FOR PERCOLATION TESTING AND SITE EVALUATION

AP 620380-A

SITE INSPECTION SHEET

PROPOSAL: Repair area needed to replace septic area needed for pool location.

LOCATION DIAGRAM

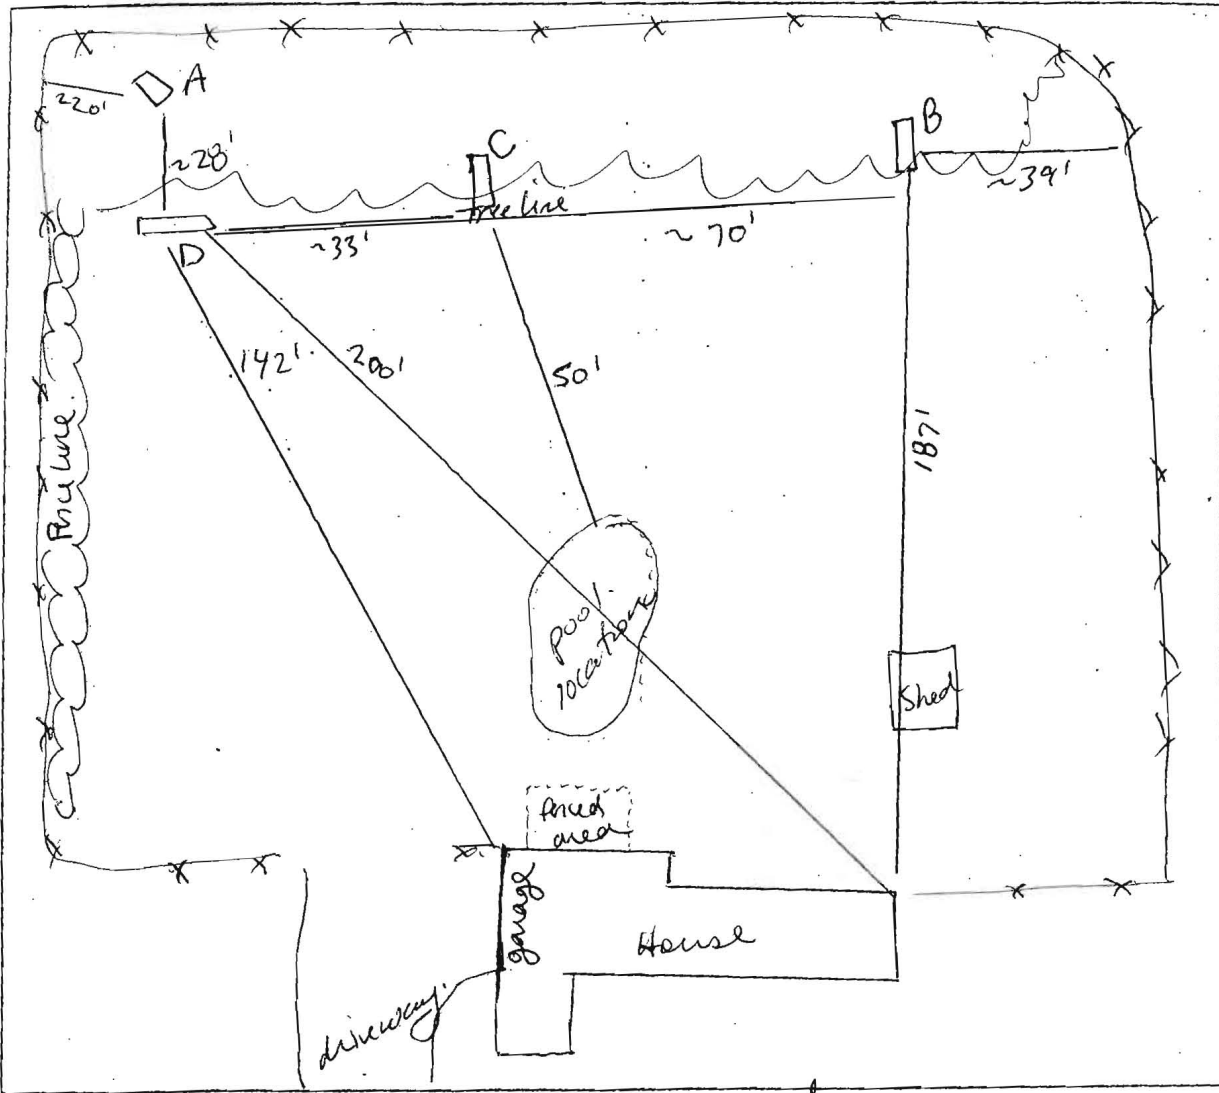
COMMENTS: From current pool location to test hole C distance was 50'
there is not adequate area w/ pool as proposed. Need to
relocate pool. 5/2/06 pool location okay and there is sufficient
area for repair.
